COA (SP) 2017-006
June 15, 2017

**STAFF REPORT
SPECIAL CERTIFICATE OF APPROPRIATENESS
FOR THE PROPERTY AT
711 UNIVERSITY DRIVE
A LOCAL HISTORIC LANDMARK**

Proposal: The application requests design approval for additions and alterations to the residence and sitework.

**Figures 2: South Elevation - Original drawing showing pergola [left]
Proposed pergola [right]**

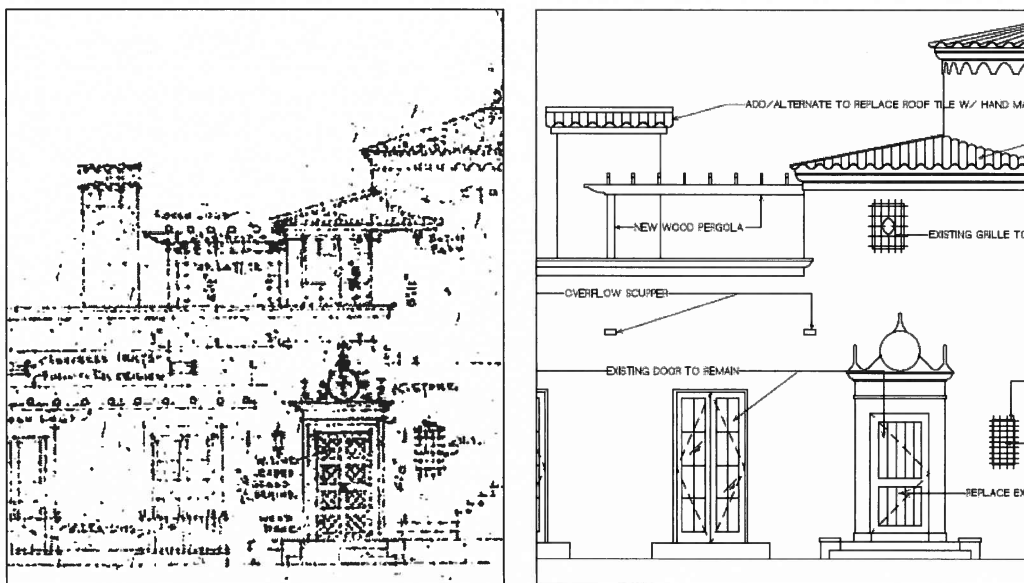
At the second floor roof terrace, a new wooden pergola is proposed to evoke the pergola shown in the original permit drawings (see Figures 2). The pergola is not visible in the earliest photograph located for the property (1940s), and it is not known if it was constructed and removed or eliminated during construction. Additional overflow scuppers are also proposed for the existing roof terrace.

- The new wood pergola at the second floor terrace should be shortened in length to achieve a proportion more consistent with the original permit drawings (see Figures 2).

Figure 3: Existing Side Door

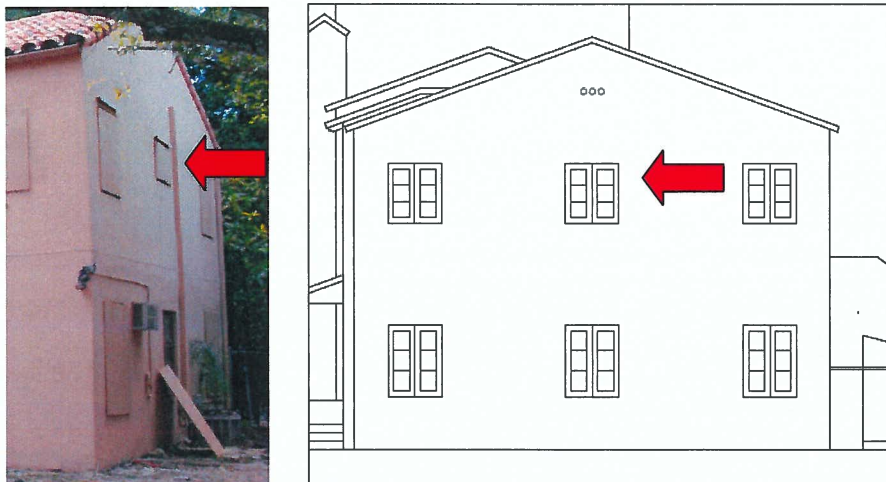
Sheet A3.1 At the east façade facing Palmarito Street, the existing doors and windows will be replaced with impact-resistant units that match the existing original windows. The existing side door is proposed to be removed. Note that the side door in the existing elevation does not depict what is actually on site. The existing door is obscured behind steel and screen security door and Staff is not able to verify if it is original to the residence at this time. The existing awnings is to be removed and a new wood canopy clad with two-piece barrel tile is proposed to provide protection for the door. Details were not provided for the canopy. The existing steps are to be replaced, but the material for the new steps was not provided. To the north, the existing garage doors (not original) will be replaced with new roll-up garage doors that are intended to give the appearance of carriage doors.

- All overflow scuppers are to be copper per the BOA recommendation.
- If Staff determines that the side door facing Palmarito Street is original, it is to remain.

Figures 4: North elevation windows – 2016 photograph [left]; existing elevation [right]

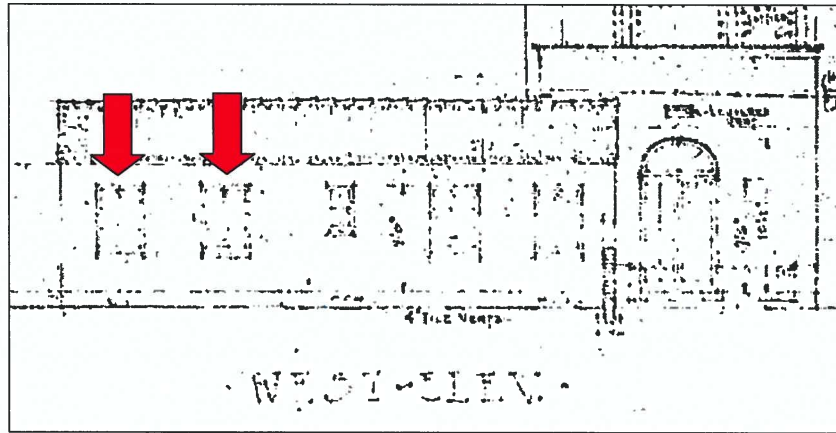
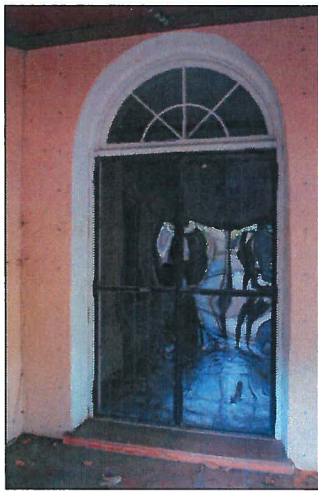
Sheet A3.2 On the north elevation, the windows are to be replaced with the exception of the middle first floor window which will be enlarged and converted into a pair of French doors. Note that the middle second floor window is not depicted correctly on the existing elevation drawings and is smaller than the two flanking windows (see Figures 4). The proposed trellis spans two-thirds of this elevation over three round concrete columns. The one-story addition on the west elevation is visible behind a new 5'-0" wall with an iron picket gate. On the east side of this elevation, the new gate (similar the west side, but smaller) proposed for the perimeter wall is visible beyond.

Figure 6: East elevation windows – listing photograph [left]; proposed elevation [right]

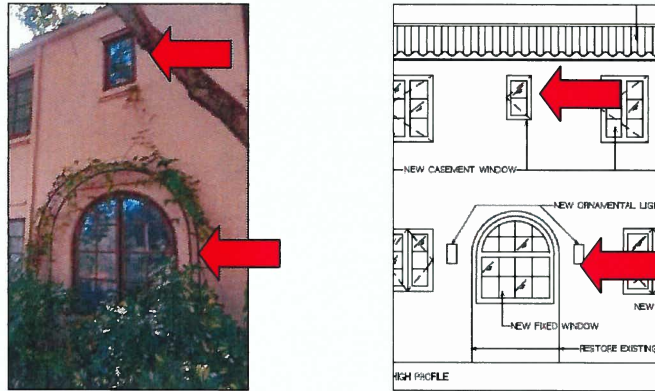
- Because the existing window openings of the residence are boarded up, Staff cannot verify that each of the windows shown on the existing and proposed elevations is correct. Discrepancies were noted between the listing photographs and the drawings (see Figure 6 for example). The existing window openings are to remain unchanged throughout (unless noted) and Staff wants the opportunity to verify that the existing windows are being matched.
